ADDENDUM NO. 01

**Bid #1488 BUILDING K CANOPY
at
SANTA ANA COLLEGE**

Project ID #3727, DSA #04-123981

February 24, 2026

SCOPE OF WORK - TEMPORARY ENCLOSURE

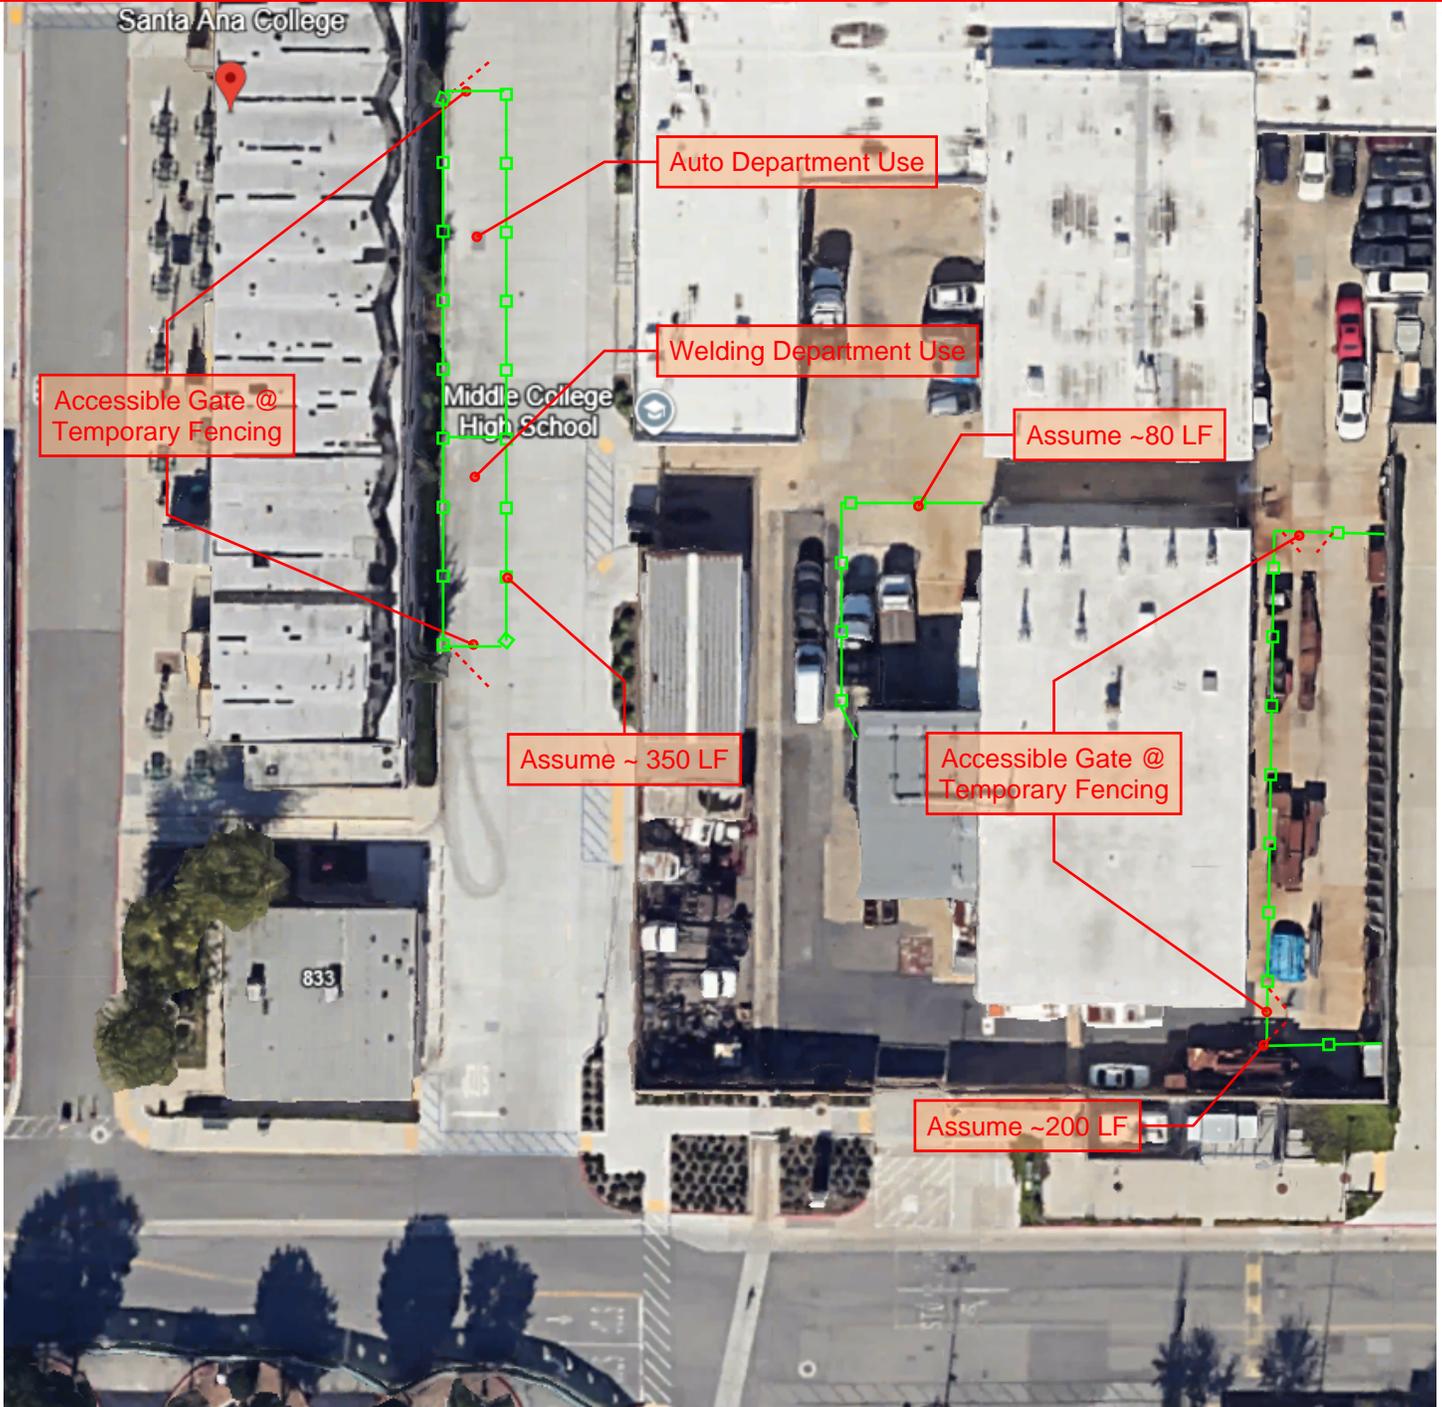
Item No. AD 1-2 Updated Logistic Plan

See updated Attachment C – Logistics Plan and Fencing Enclosure

- 1.) Fencing enclosure will contain the lay-down & equipment area, including working area.
- 2.) Fencing is to be minimum 6-feet in height.
- 3.) Fencing is to be provided with fence panel foot stands and sandbags.

- 4.) Fencing is to be with fabric and maintained during high winds and or in a event of vandalism.
- 5.) Fencing gates are to be provided for egress and emergency responses.

- 6.) Construction signage is to be posted at perimeter of fencing for public awareness.
- 7.) Porta-potty to be housed within the contractor lay-down and working area.

- 8.) Fencing is to be secured and maintained by the contractor.
- 9.) All storm water drains, grates, catch basins are to be protected from debris, rubbish and or spoils born and or imported to the site.

- 10.) Contractor to perform Best Management Practices focused on erosion and sediment control to keep soil and pollutants out of storm drains and waterways.

Utility Survey and S1 Overlay Plan (For Reference Only)

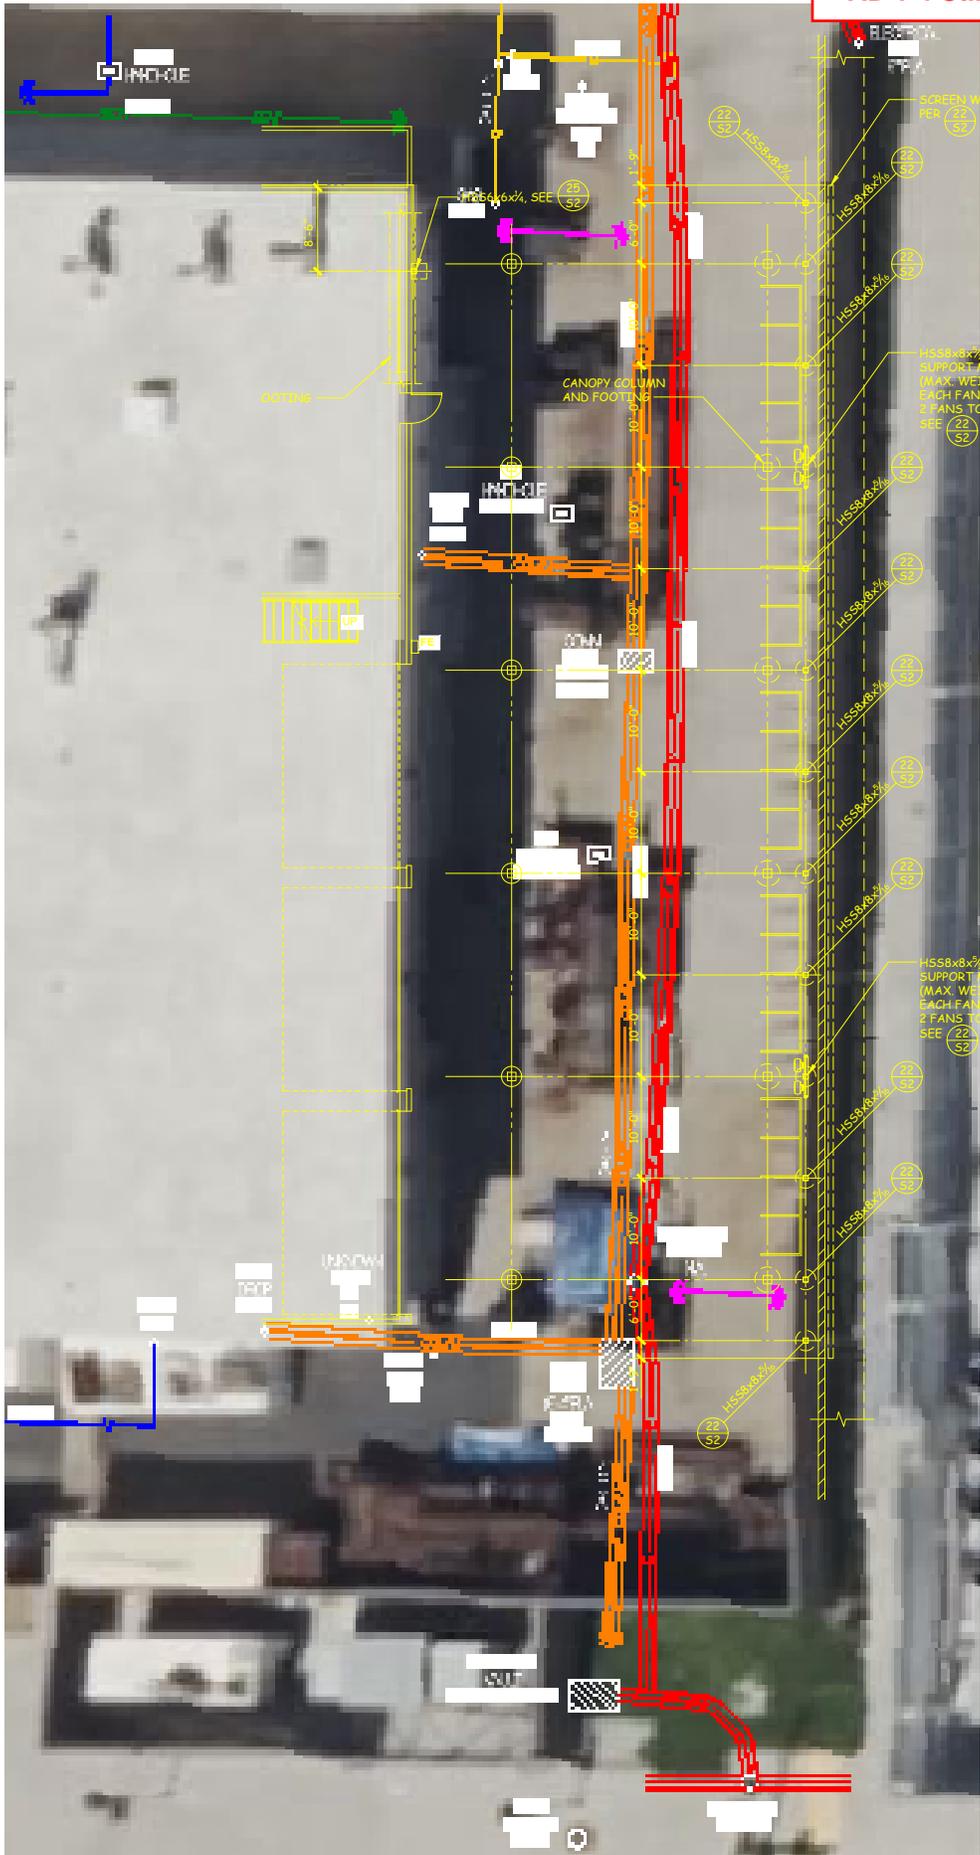
Item No. AD 1-4 Utility Survey Overlay

See additional Utility Survey and S1 Overlay Plan attached for reference only.

PROJECT NAME:	Building K Canopy Project at Santa Ana College		
PROJECT NUMBER:	3727	BID NUMBER:	1488
EMAIL TO: facilitiesbid@rsccd.edu			
DATE:	2-10-26		
FROM:	Sanders Construction Services, Inc	EMAIL:	MeganL@sandersconstruction.com
SPEC SECTION:		DRAWING NUMBER:	
REQUESTED CLARIFICATION:			
<p>The potholing utility survey doesn't provide a schematic of the located underground lines onto the drawings in any meaningful way.</p> <p>1) Can you have the pertinent underground utilities plotted out on the S1 sheet so we can see if there are any potential conflicts with the canopy or wind screen caissons?</p> <p>2) What will happen if there are direct conflicts with the existing utilities and caissons?</p>

RESPONSE TO CLARIFICATION:			
<p>Response 1.) Refer to AD 1-4 Utility Survey Overlay.</p> <p>Response 2.) District and design team will provide clarification through the construction RFI process.</p> <p>RSCCD 2/20/26</p>
